March 14, 2001
CEOG-01-065

Subject: Transmittal of Approved Topical Report CE NPSD-1168-A, Rev 00

Joint Applications Report for Containment Isolation Valve AOT Extension

CE NPSPD-
1168-A, Rev 00

Figure 15: Schematic of Penetration Connected to Safety-Related Cooling Water Line -- Penetration Path E4

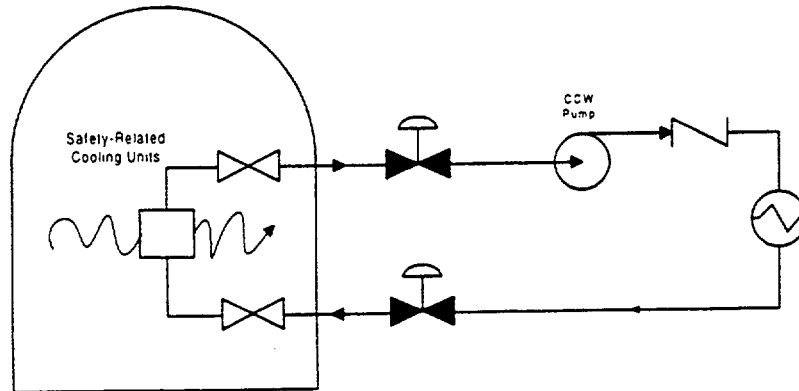
ID	Description of Penetration Flow Path	Calculation Method	Comment
E4	CIVs in penetrations used to support containment heat removal function using fan coolers (See Figure 15)	$SAOT_{trial} = ACDF \cdot P_f \cdot P_n \cdot \frac{AOT}{8760}$ $= 2.30E-13 \text{ for closed loop}$ $= 3.84E-10 \text{ for open loop}$ <p>where</p> $SAOT_{trial} = \text{single AOT risk for large early release}$ $ACDF = \text{change in CDF, baseline CDF assumed to be: } 2E-4/\text{yr}$ $P_f = \text{probability of a pipe failing to isolate the associated containment penetration: } 1.0E-4$ $P_n = \text{probability of a pipe failure in the closed loop system outside the containment: } 6.0E-4 \text{ (closed loop), or } 1.0 \text{ (open loop)}$ $\frac{AOT}{8760} = \text{fraction of full duration of AOT (i.e., 168 hours) to a year}$	<p>Specific Assumptions:</p> <ul style="list-style-type: none"> The containment Penetration has a MOV on the outside and a normally open manually operated valve inside the containment where the MOV is the CIV that fails and is secured in the open position. Only a random piping failure can establish a pathway from containment to the environment with a conditional probability of $1.0E-4$ during the proposed AOT. Inadvertent opening of a relief valve will also breach the piping outside of containment and is given a probability of $5.0E-4$ for the proposed AOT. A breach in the piping of both inside and outside containment must fail for a pathway to the environment. Securing the MOV in the closed position will result in an action per TS. The proposed AOT for an inoperable CCS cooling water line CIV is 7 days. <p>REVIEW COMMENTS:</p> <ul style="list-style-type: none"> The unaffected CIV is assumed to be OPERABLE. Crediting close loop system outside containment as a barrier is applicable to cases in which the affected valve (the valve under CM) is intact. If not true, the value of $SAOT_{trial}$ would increase by approximately three orders of magnitude.
